## Certificate of Appropriateness Case Report

HEARING DATE: JUNE 20, 2018

*Filing Date:* July 19, 2017  
*Case No.:* 2017-001456COA  
*Project Address:* 1100 FULTON STREET  
*Historic Landmark:* Alamo Square Landmark District  
*Zoning:* RM-1 (Residential-Mixed, Low Density)  
40-X Height and Bulk District  
*Block/Lot:* 0777/005  
*Applicant:* Serina Calhoun  
Syncopated Architecture  
657 Fillmore Street  
San Francisco, CA 94117  
*Staff Contact* Jonathan Vimr – (415) 575-9109  
jonathan.vimr@sfgov.org  
*Reviewed By* Tim Frye – (415) 575-6822  
tim.frye@sfgov.org

## A3.1

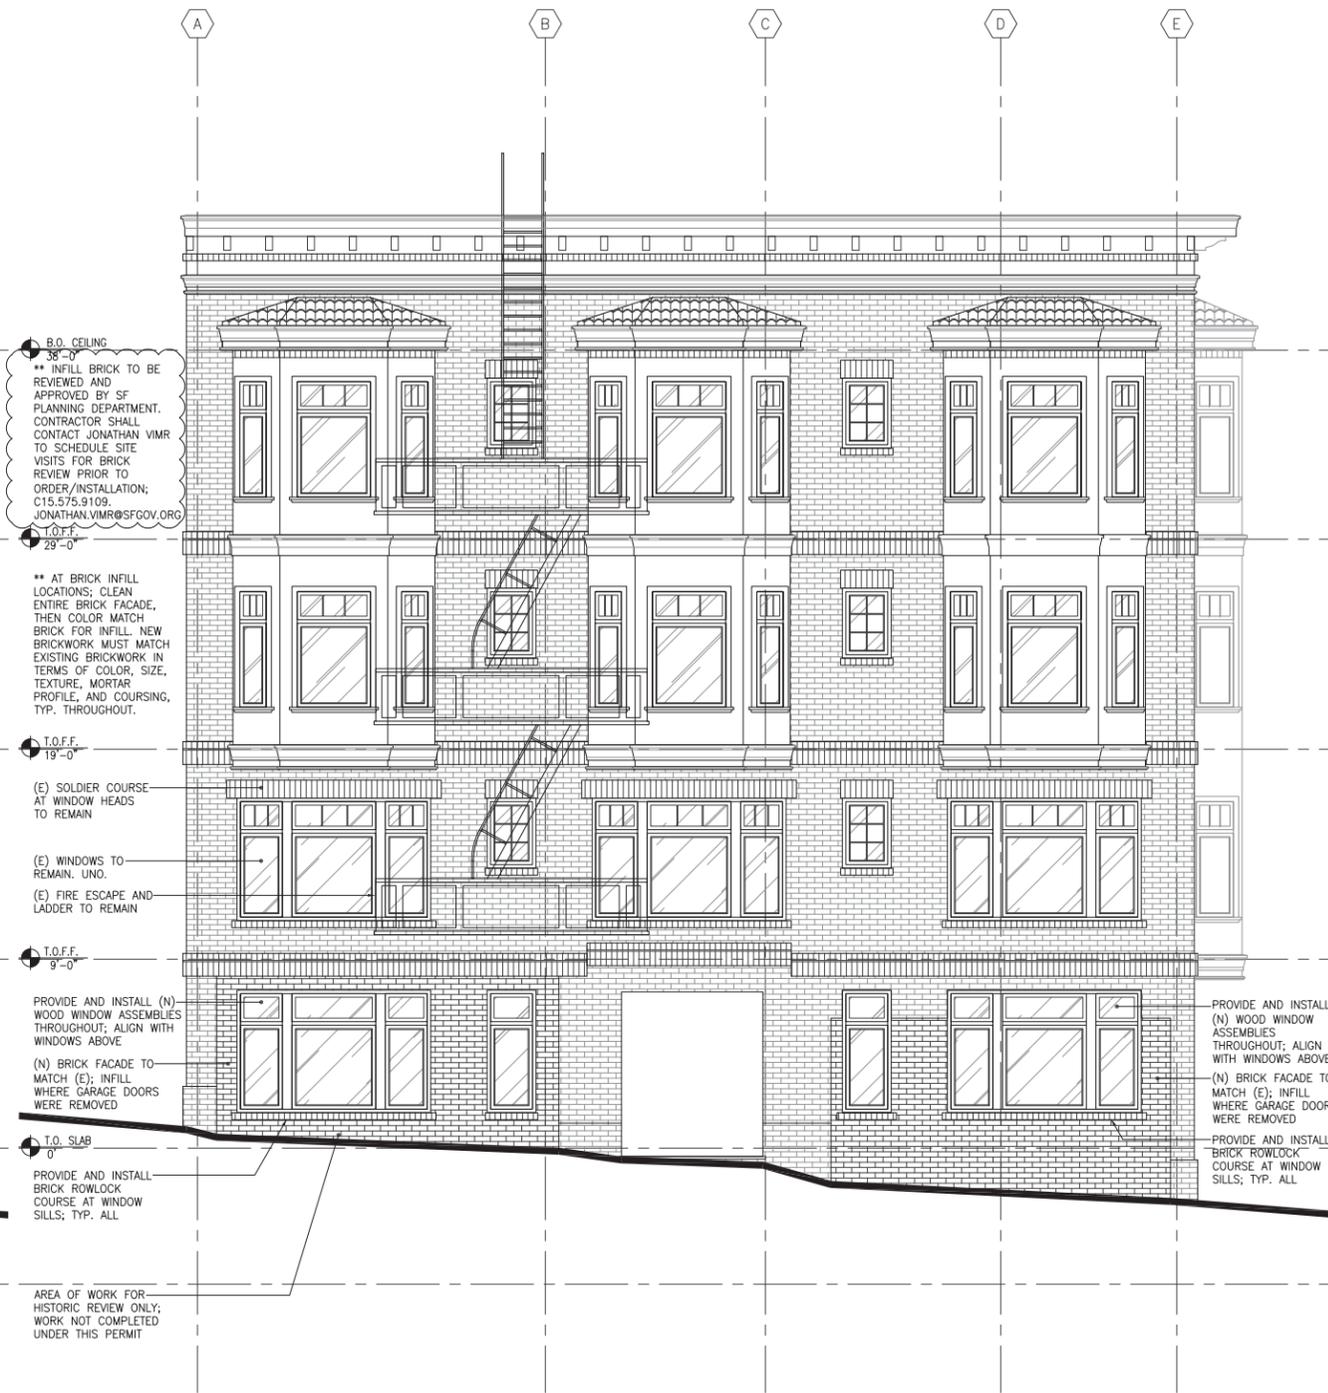
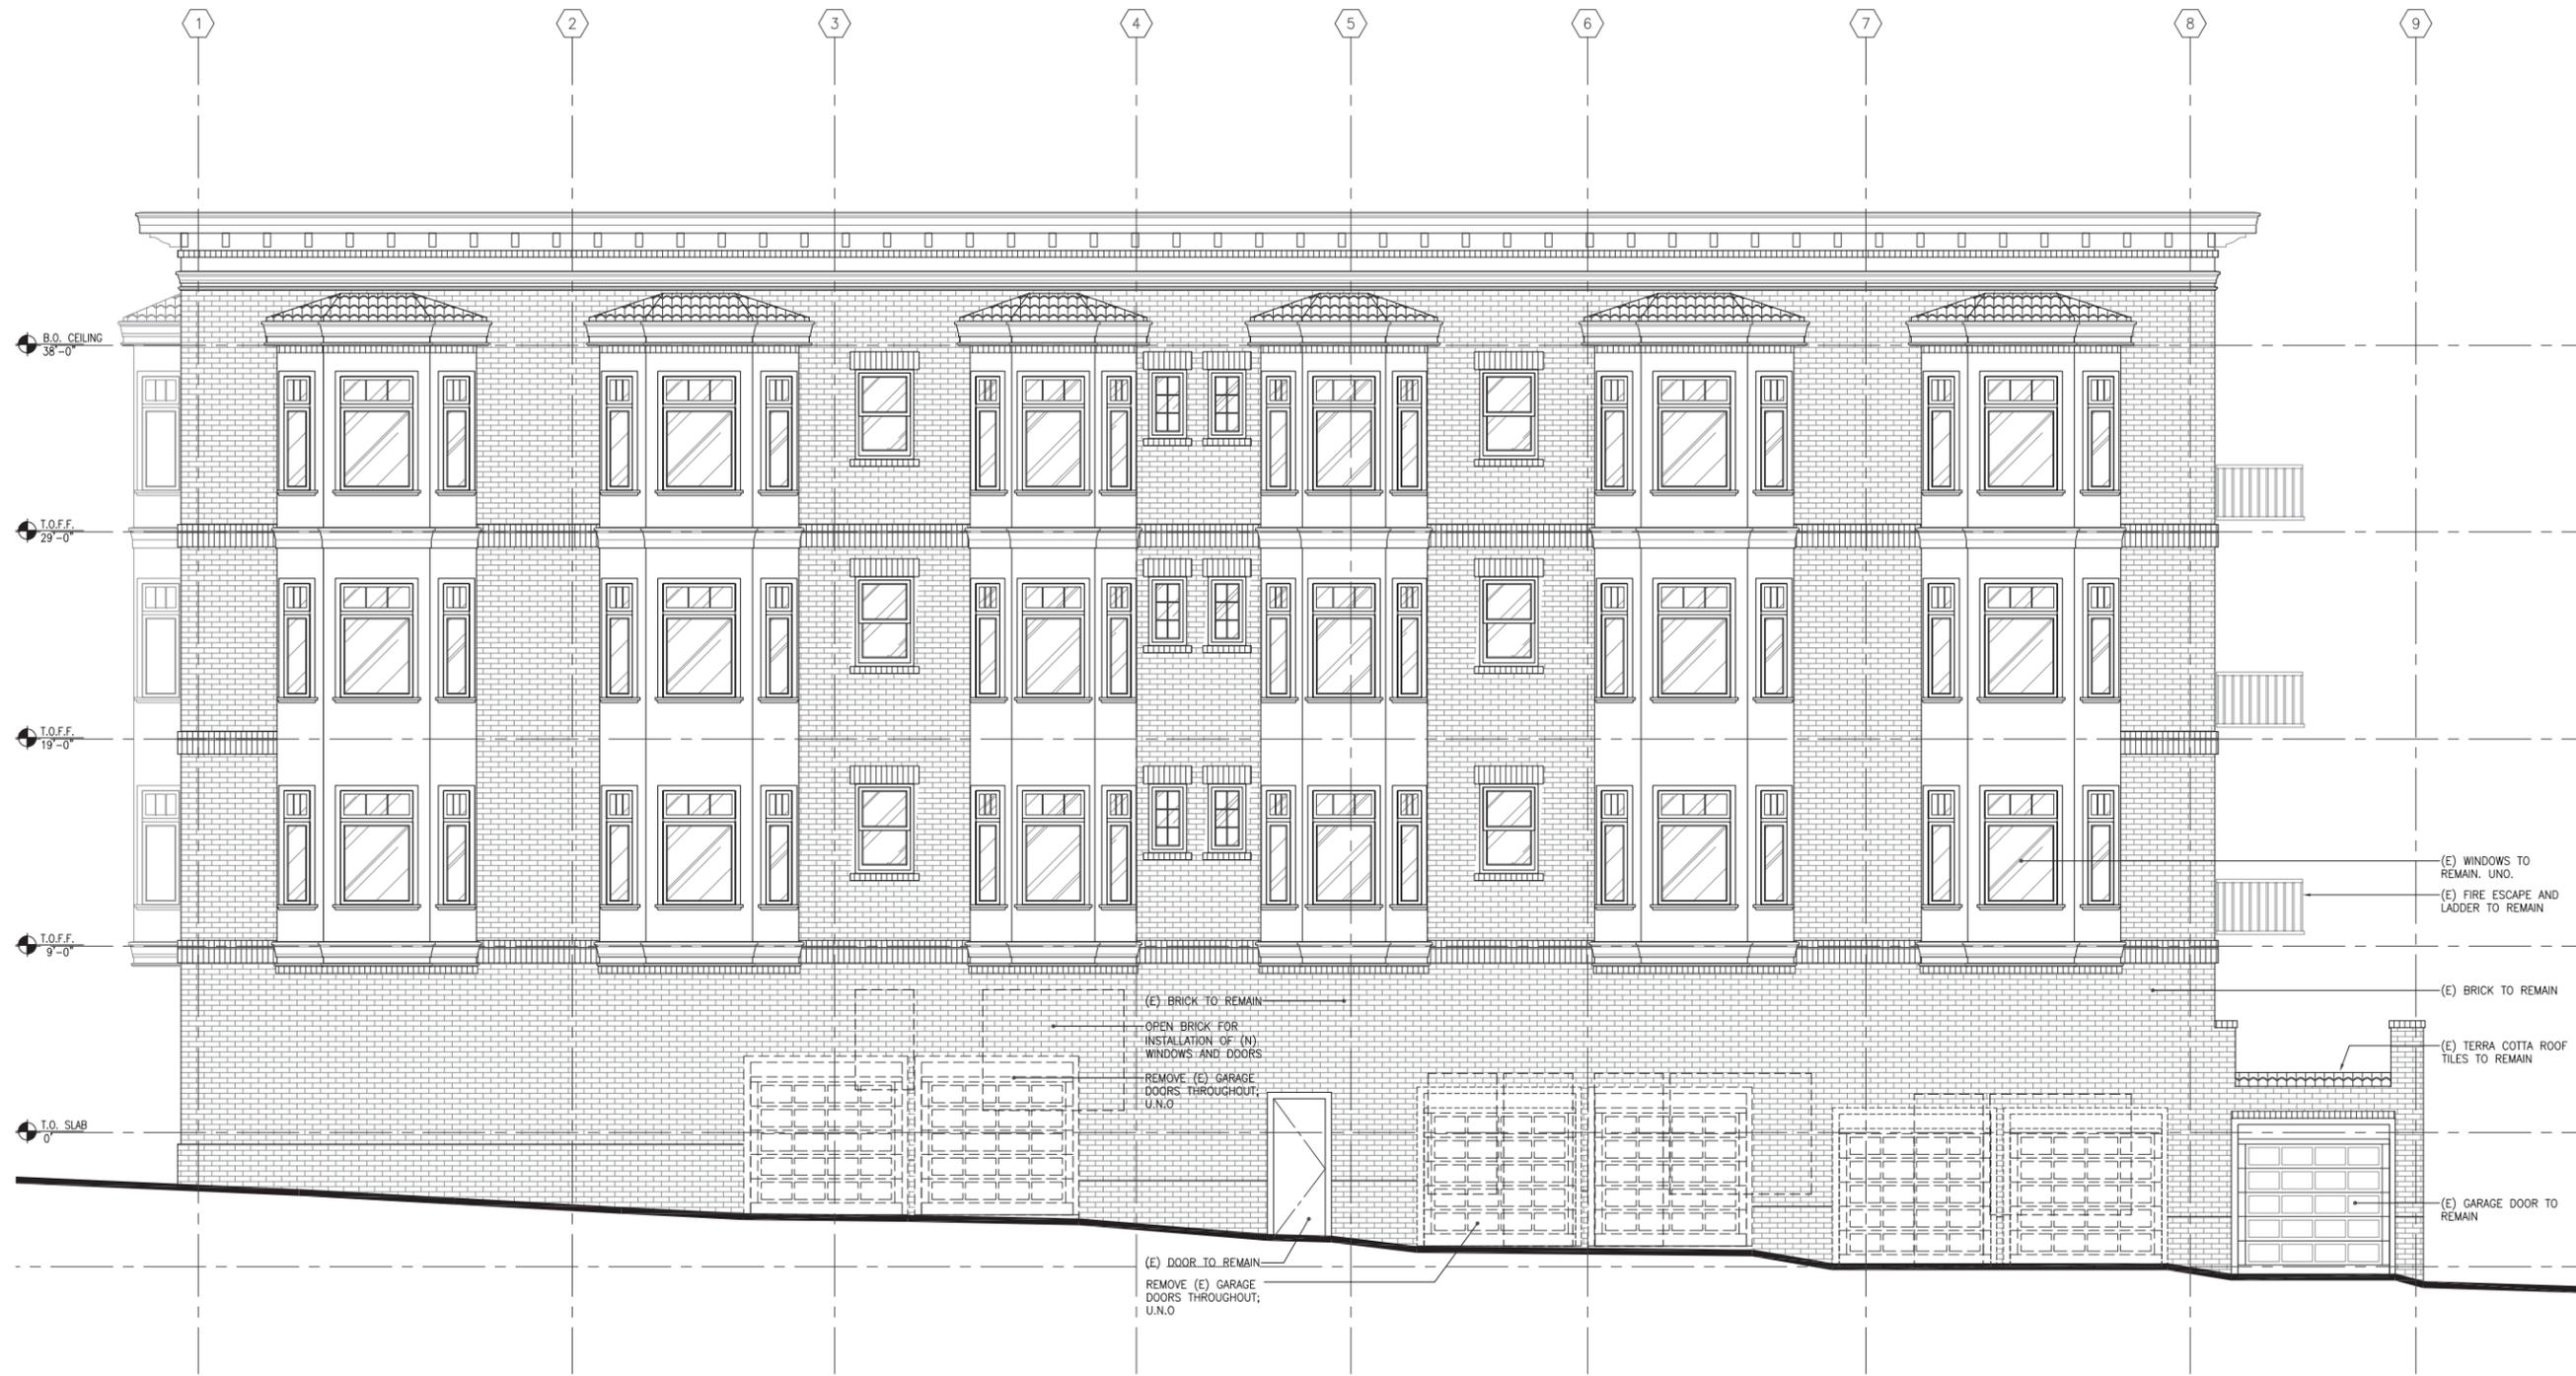
*The proposed project includes exterior alterations to the subject property, including the modification of ten garage openings at the ground level and the installation of new wood windows and paneled doors within these openings. While original to the building, the garage openings are not character-defining features of the building, and as such, their removal will not destroy historic materials, features, and spatial relationships that characterize the property. The designating ordinance (Appendix E to Article 10 of the Planning Code) states that the character-defining features of the District are the exterior architectural features of the buildings in addition to street and park furniture. The corresponding Landmark Preservation Advisory Board's case report more specifically describes these features as including painted wood siding; the elaborate ornamentation of Victorian style buildings; consistent fenestration patterns; bay windows; paneled entries with accompanying porticos; obscured roofs; double-hung wood windows; front steps; designs responsive to hillside topography; and notes that larger, compatible apartment block buildings—such as 1100 Fulton—frequently punctuate corners within the District and include traditional compositions with subdued classical revivalist ornamentation focused on cornices and entries. Nowhere is auto-oriented development discussed, nor are garages noted as character-defining or even mentioned beyond reference to small garages on two of the four vacant lots present within the District at the time of designation. As new windows and doors will be roughly flush with the brick cladding, the structure's defined base in contrast to the projecting bays of the upper levels will be retained and no ornamentation will be altered. The new wood windows at the ground floor will be compatible with the historic windows at the building, in that they will match the materials and operation of the historic windows, while also being differentiated from the historic windows due to the absence of a divided-lite transom and the different proportions of the individual windows on the Fulton Street façade. The new windows will also achieve compatibility with the overall fenestration of the building through alignment with the windows found at the upper levels as well as matching profiles. Overall, the proposed project maintains the historic integrity of the subject property since the new windows and doors are compatible with, yet differentiated from, the historic building. Therefore, the proposed project complies with Rehabilitation Standard 9.*

The project will involve the removal of a limited amount of historic brick at the base of the building in connection with the garage opening modifications and installation of new windows and doors. New polychromatic brick matching the historic brick will be installed around the new features; to ensure that the maximum amount of historic brick is retained, and that the new brick will align with the historic brick, a materials conservator will review and approve replacement brick and mortar samples as well as repair methods for any brick damaged during construction. Planning Department staff and the materials conservator will also oversee the installation of the new brick during construction, including the review of a mockup of new brick installation.

1. As part of the Building Permit, a materials conservator shall be retained by the Project Sponsor to review and approve replacement brick and mortar samples as well as repair methods for any brick damaged during construction.

2. As part of the Building Permit, Planning Department preservation staff and the materials conservator shall oversee the installation of the new brick during construction, including the review and approval of a mockup of new brick infill.
